## PRODUCT CHANGE NOTIFICATION

- 1.5" and smaller Male Threaded Mounting Plates with standard threads (MM Series).

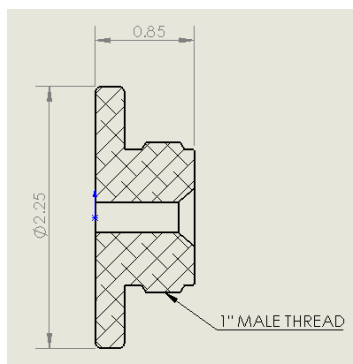
- The flange diameter of Kocher's **1.5" and smaller male threaded mounting plates with standard threads has been reduced**, as follows:
  - All sizes 1.5" and below originally had a 2.25" flange diameter.
  - Now 1.5" plates will have a 2" flange diameter, and 1" & below plates will have a 1.5" flange diameter.
